MEMORANDUM

To: Eric R. Shields, AICP, SEPA Responsible Official
From: Jon Regala, Senior Planner
Date: March 2, 2015
File: SEP14-02467/SEP13-00959
Subject: SEPA ADDENDUM
MODIFICATION TO LAKE STREET PLACE MIXED-USE PROJECT

Lake Street Place Project

2ND FLOOR / PARKING 'A' FLOOR PLAN
 1/16" = 1'-0"

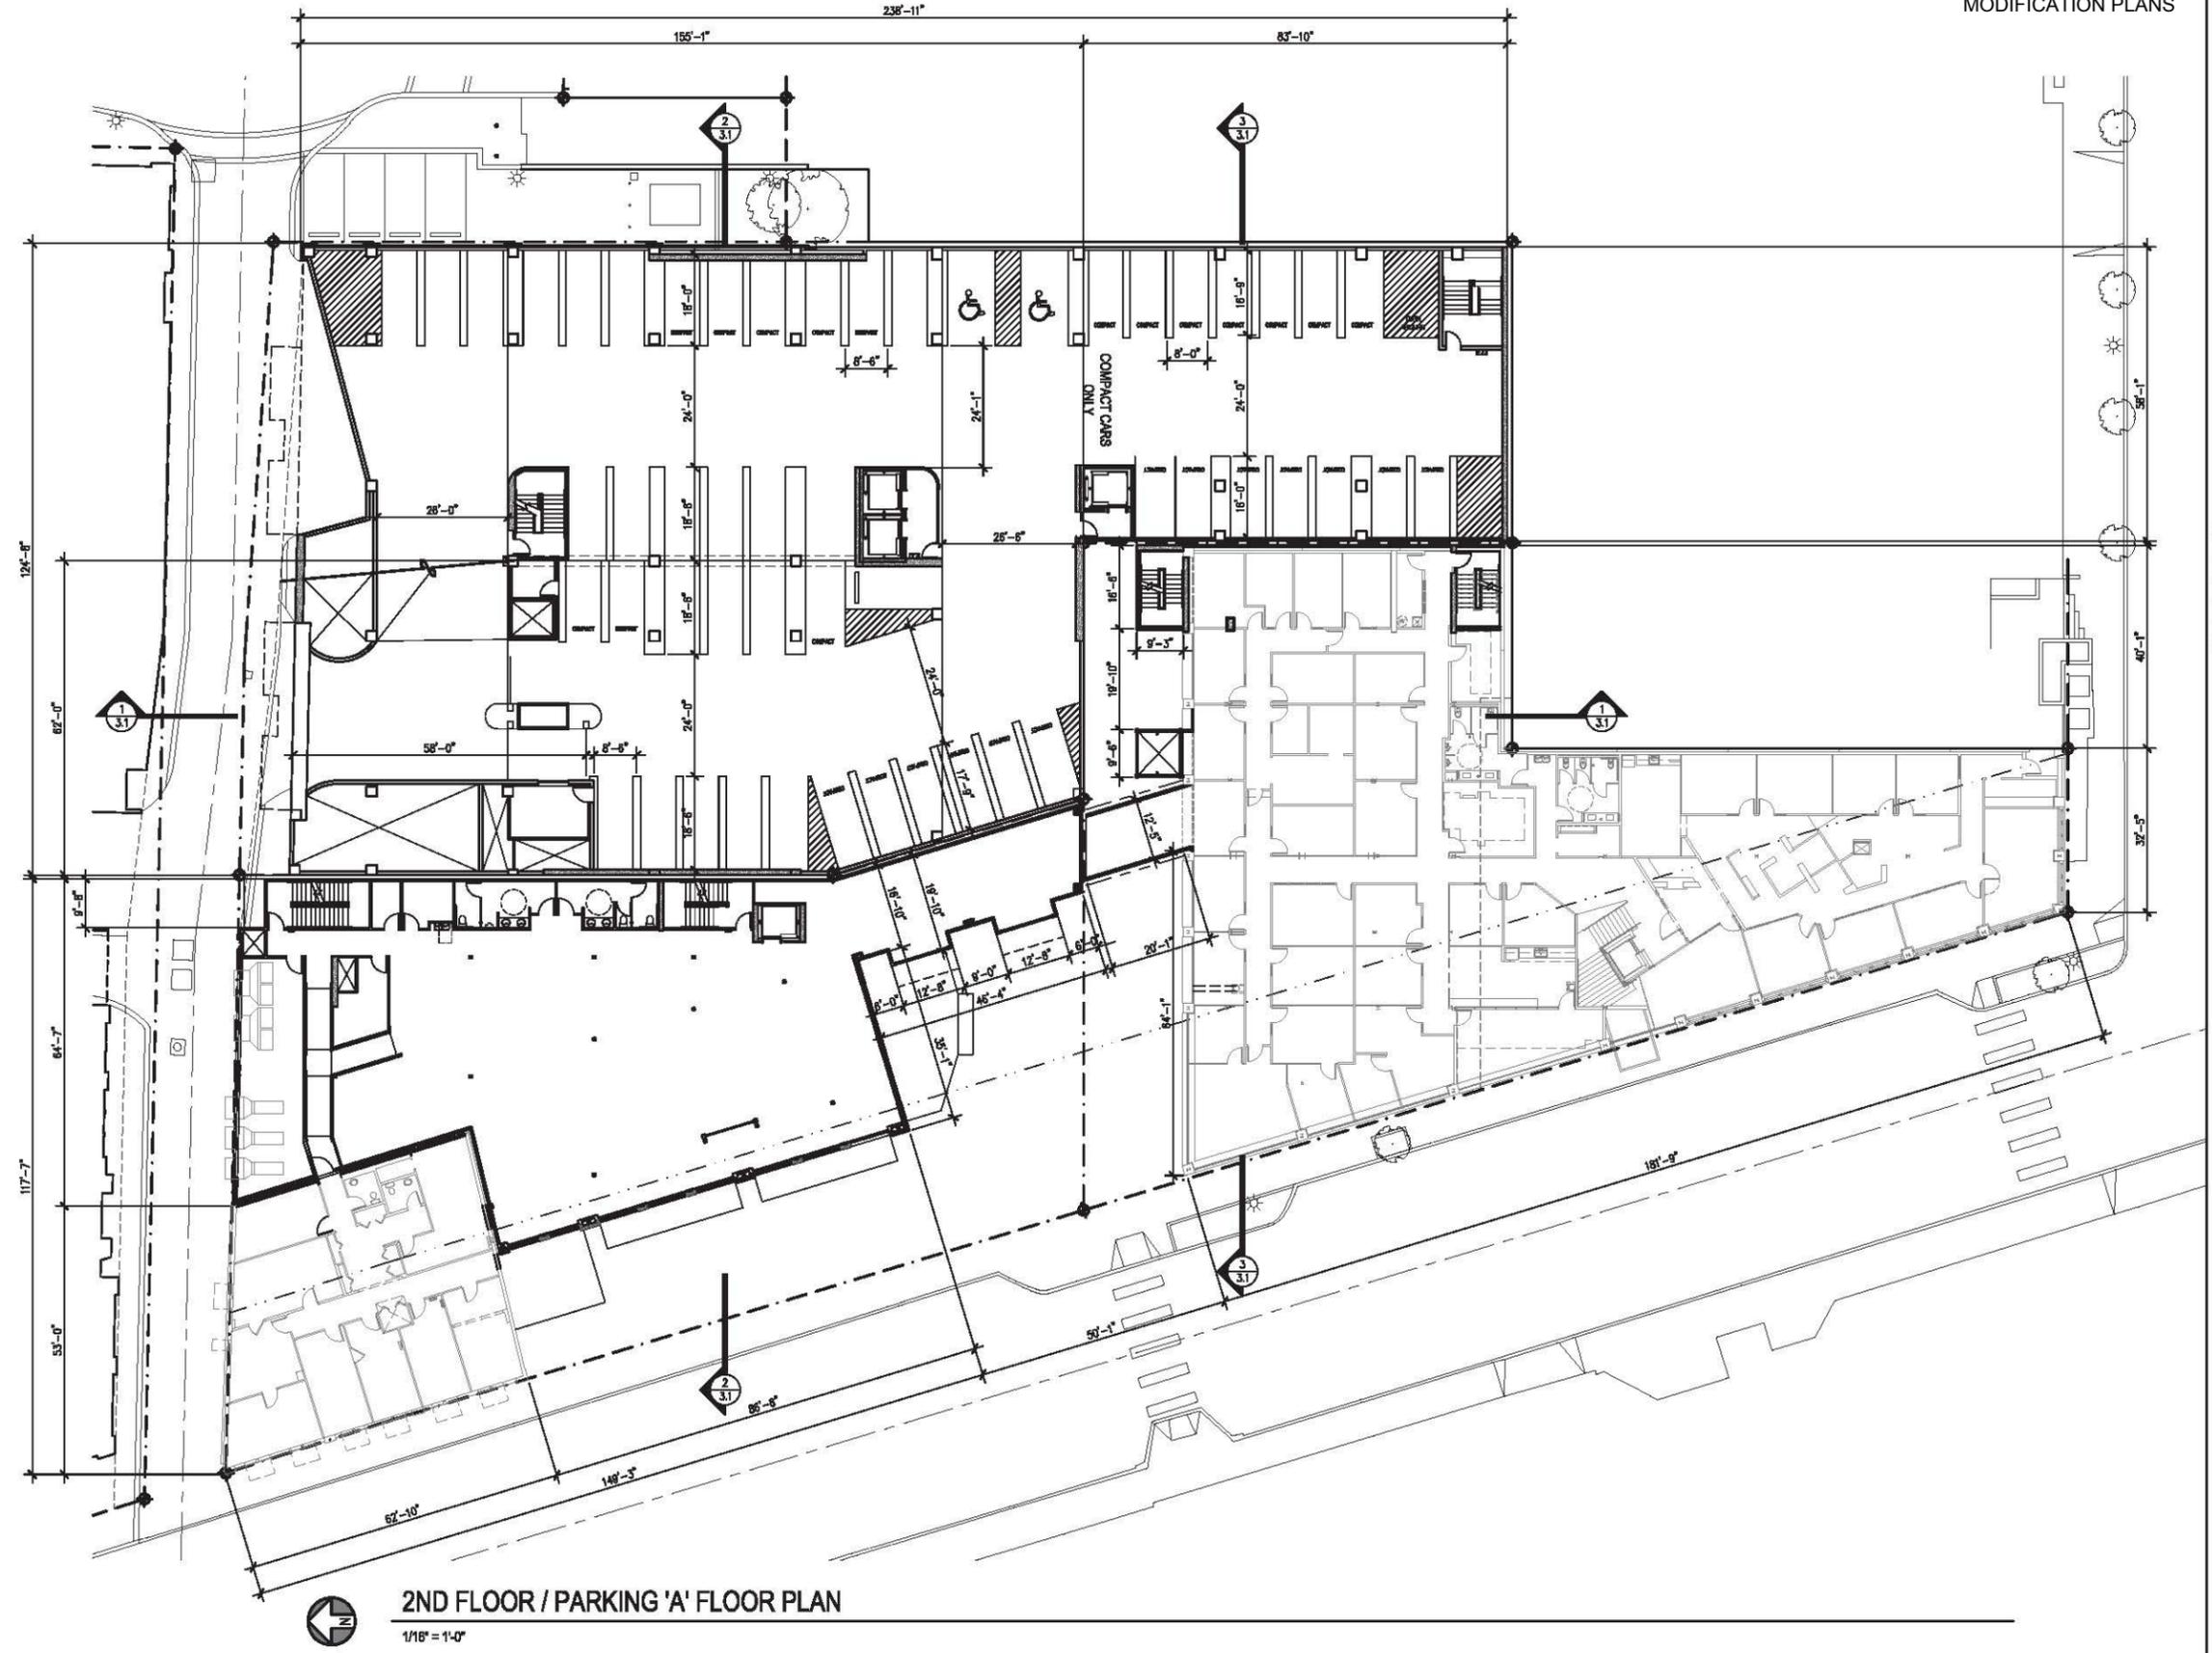
- Kirkland Waterfront Market Building. Replace the 20'-wide 4-story addition to the north side of the building with separate stair and elevator components. Between the two is a ground floor expansion to the existing Milagros restaurant.

The Kirkland Waterfront Market (KWM) building will be modified to remove the 20ft wide 4 story addition to the north side of the building. In lieu of the 20ft addition, we are reconfiguring the layout of the new stair and elevator into two separate “towers” with an expansion to the restaurant space at the 1st floor between the two towers.

3RD FLOOR / PARKING 'B' FLOOR PLAN

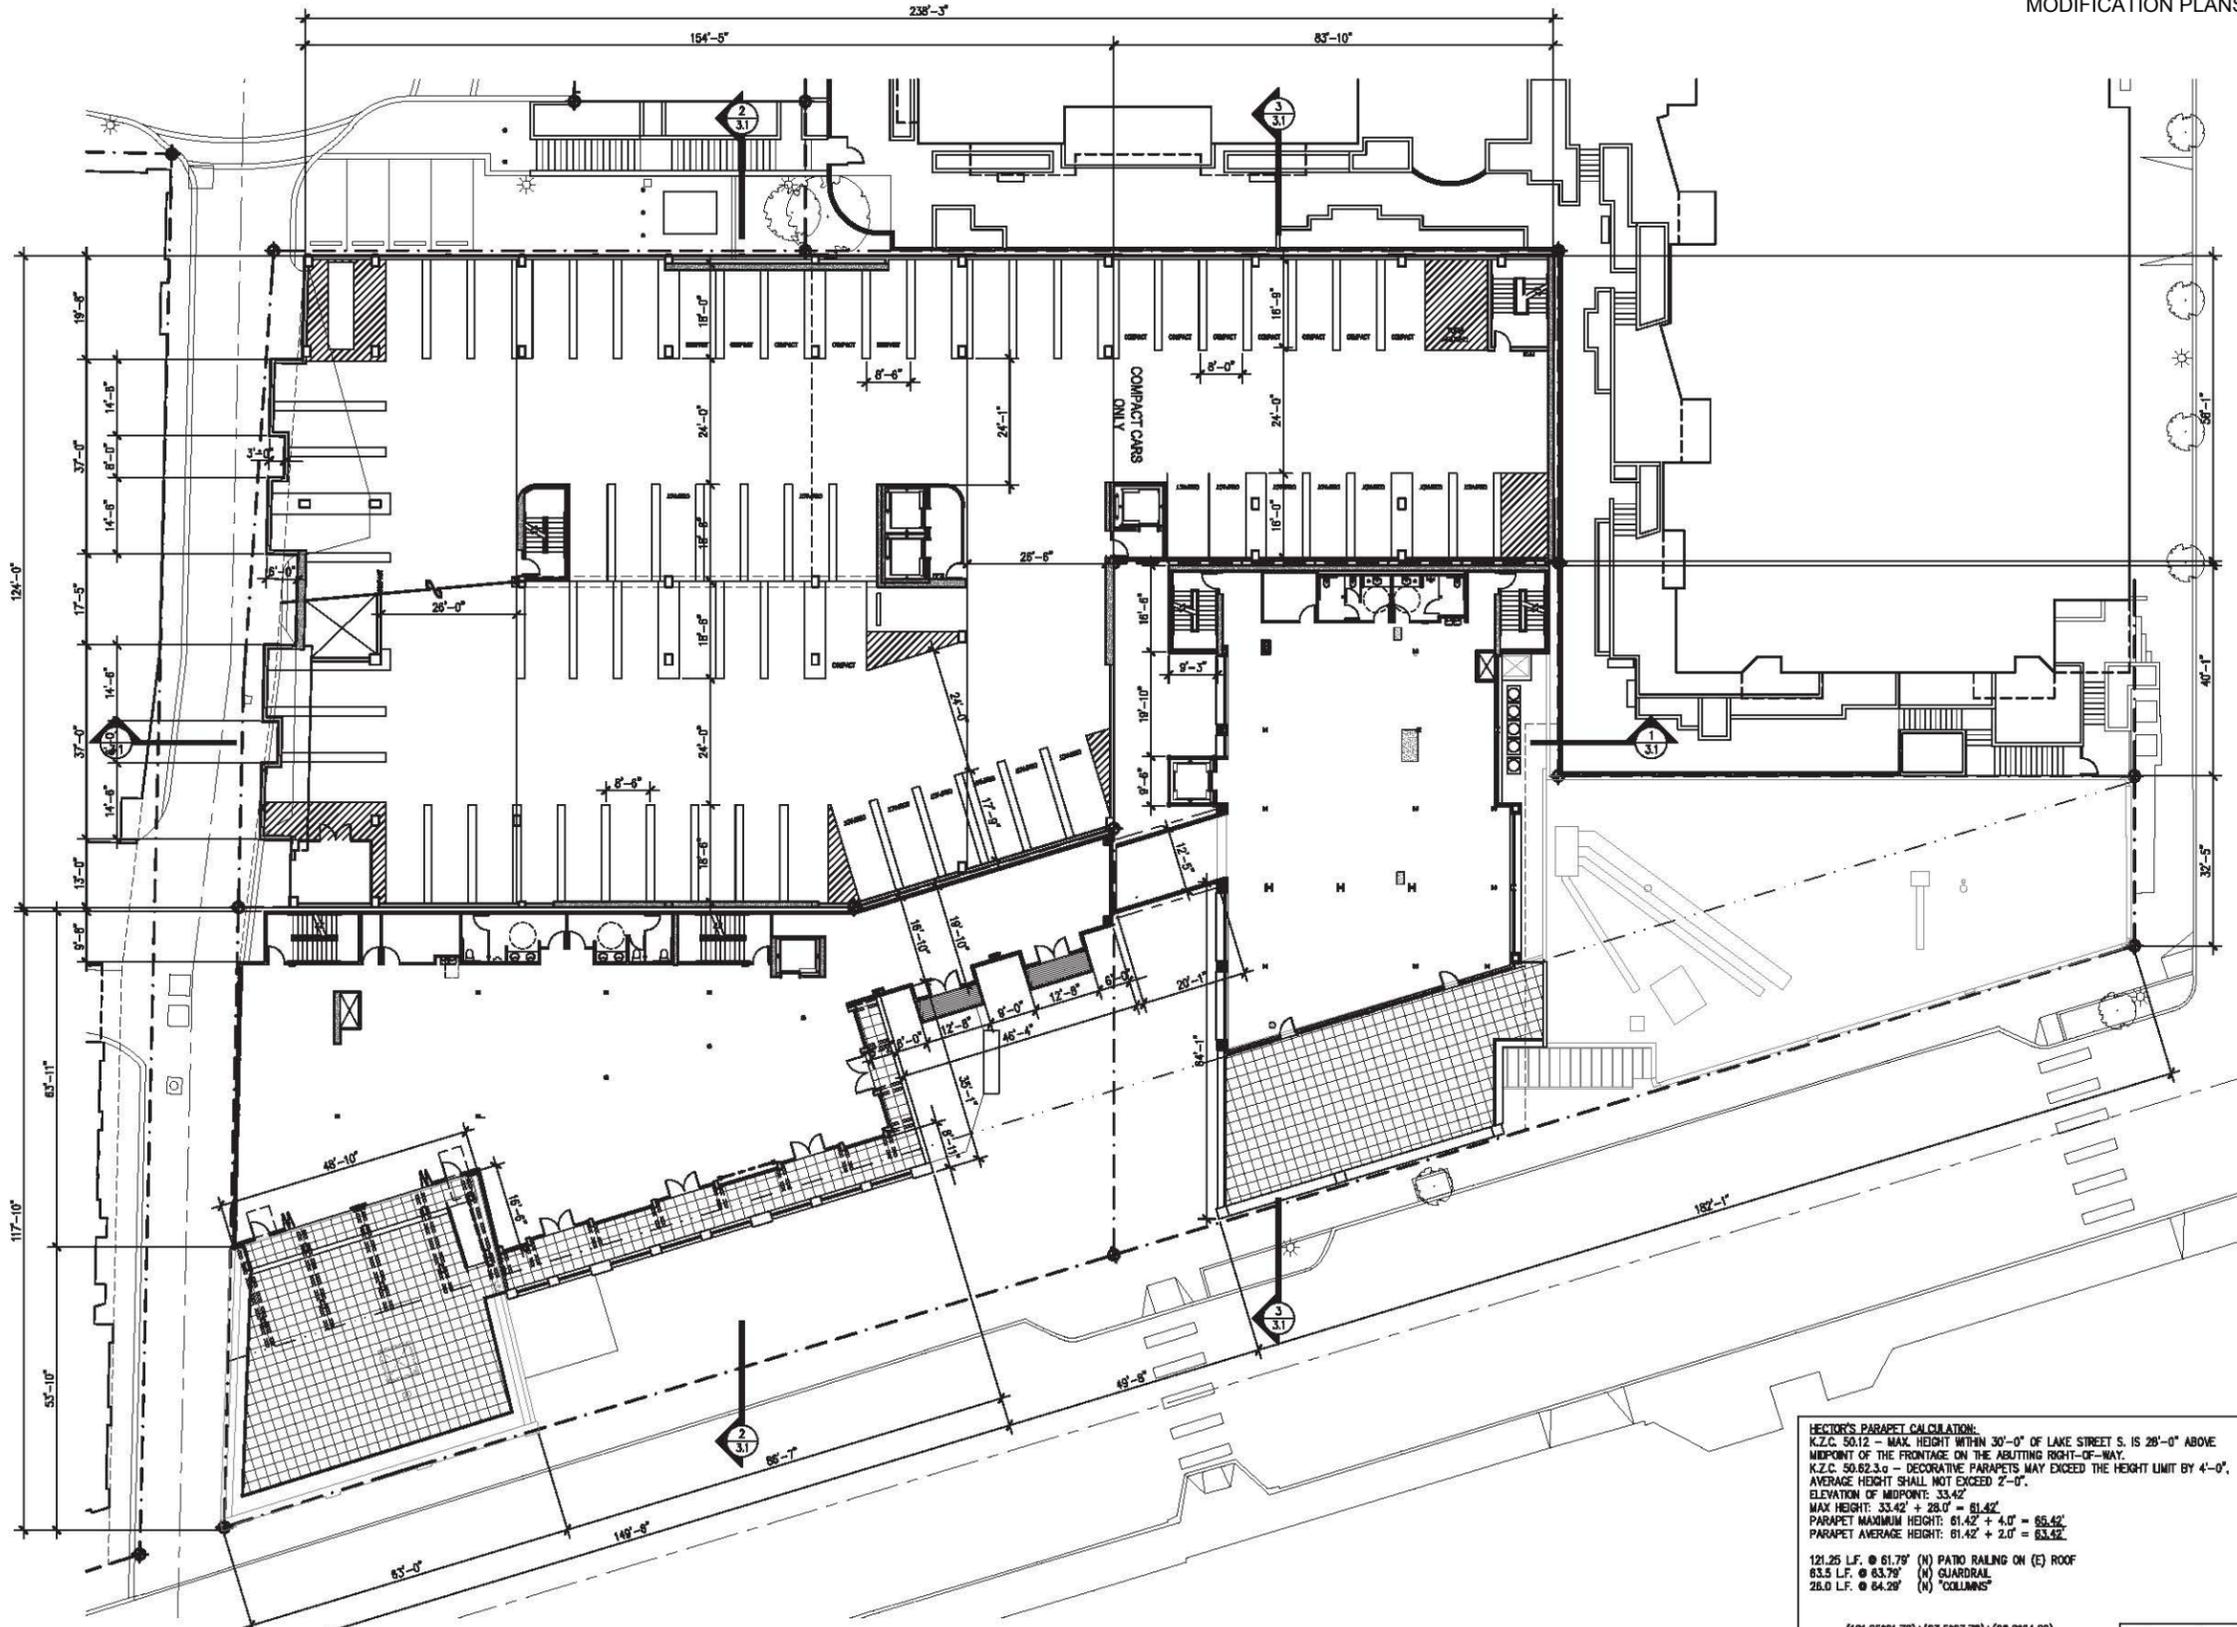
- Hector's Building. Remove the entire 4th floor and step back the 3rd floor atop the Hector's restaurant building. A new rooftop deck and trellis is proposed to be accessed from the 3rd floor. The mechanical screen at the roof has been replaced with a chimney structure that is set back from the north roof edge.

The Hector’s building will be modified to remove the entire 4th floor and step the 3rd floor back from over the existing building at the north. The existing building will receive a rooftop deck and trellis to be accessed from the 3rd floor. This change significantly reduces the scale of the building. Also, the mechanical screen at the roof has been replaced with a “chimney” structure that is pulled back from the north roof edge.
